Re: **Grants Reclamation Project**
Docket No. 40-8903 License No. SUA-1471
***Corrections / Edits for "Background Water Quality Evaluation of the Chinle
Aquifers" – October, 2003 and Associated Statistical Analyses Document***

**REPLACEMENT PAGES
JUNE 2004**

**GRANTS RECLAMATION PROJECT
BACKGROUND WATER QUALITY EVALUATION
OF THE CHINLE AQUIFERS**

**STATISTICAL EVALUATION OF CHINLE AQUIFER
QUALITY AT THE HOMESTAKE SITE NEAR GRANTS, NM**

FIGURE C.3-6. MOLYBDENUM CONCENTRATIONS FOR MIDDLE CHINLE WELLS ACW, CW1, CW2, CW14, CW28 AND WCW IN MIDDLE CHINLE NON-MIXING ZONE.

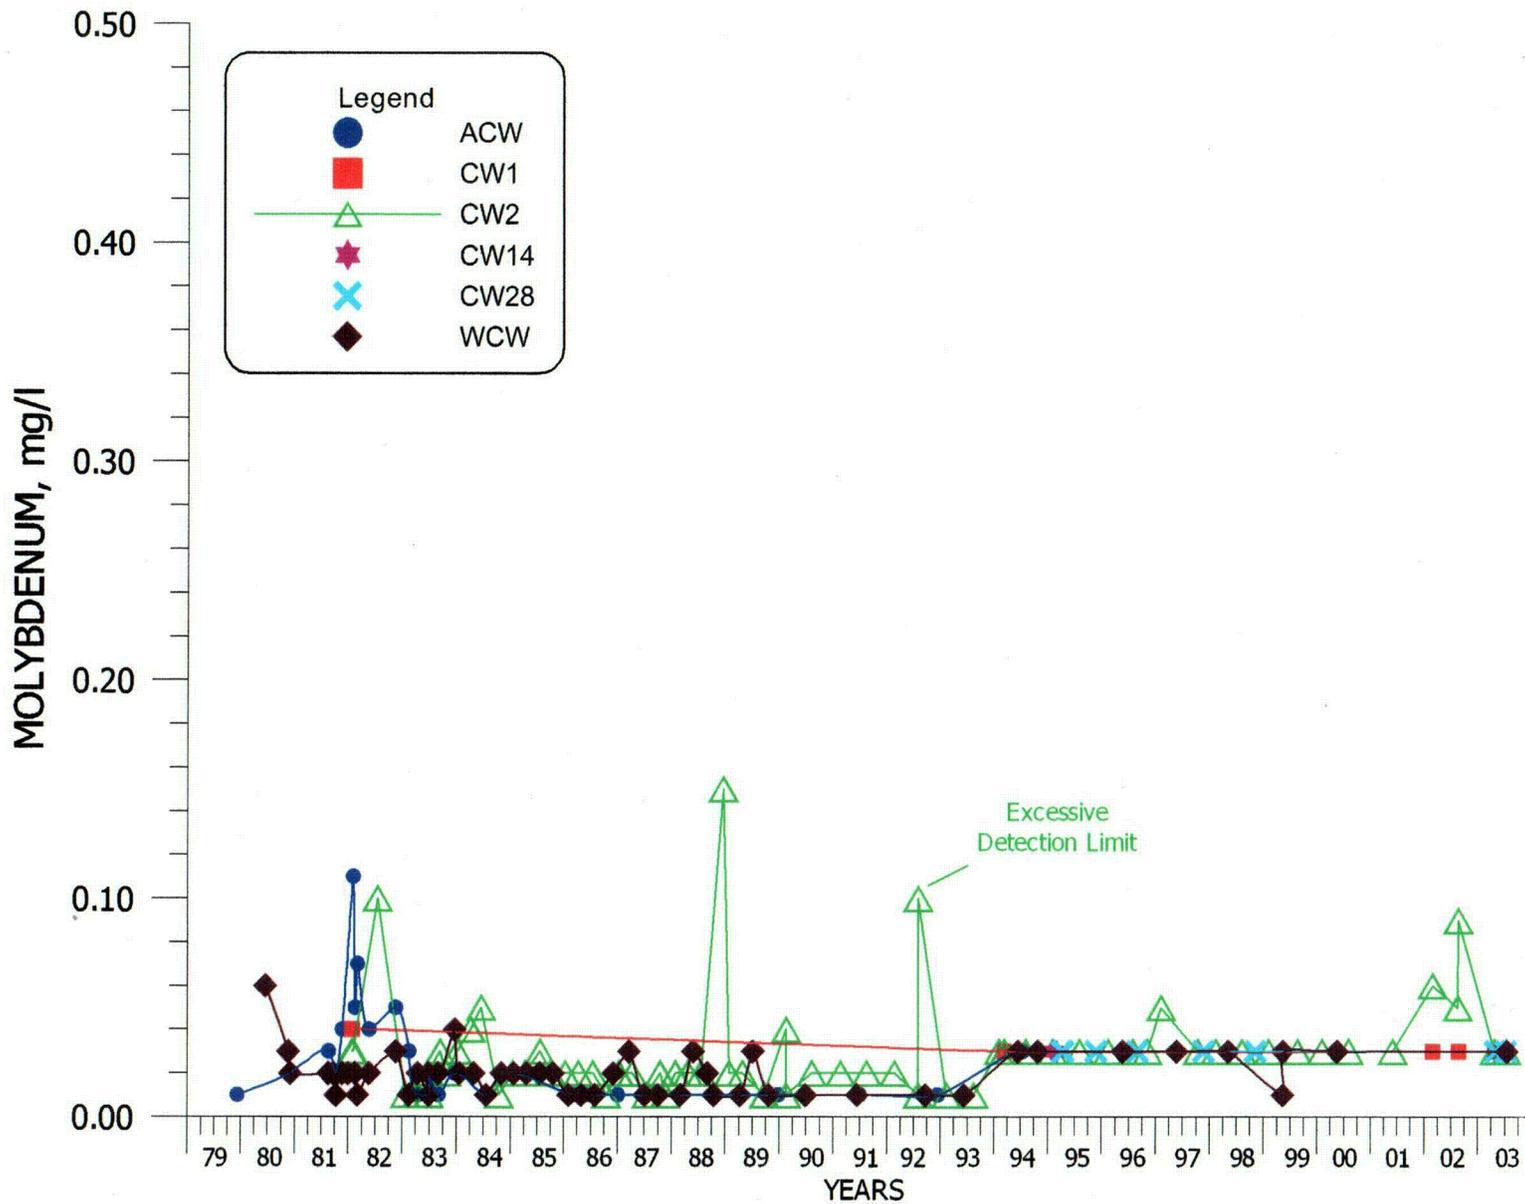
<u>Page No.</u>	<u>Action and Changes</u>
Cover	Replace cover page
Page ES-3	Replace pg ES-3 with pg ES-3 modified Table ES-1 vanadium and thorium-230 values
Pgs. 6-1 and 6-2	Replace pgs 6-1 and 6-2 with pgs 6-1 and 6-2 modified Table 6-1 vanadium detection value on pg 6-2, pg 6-1 just reprint
Page 6-11	Replace pg 6-11 with pg 6-11 modified Table 6-4 vanadium and thorium-230 values
Figure C.2-6	Replace Figure C.2-6 (pg C.2-8) with Figure C.2-6 (pg C.2-8) modified with note of excessive detection limit
Figure C.3-6	Replace Figure C.3-6 (pg C.3-8) with Figure C.3-6 (pg C.3-8) modified with note of excessive detection limit
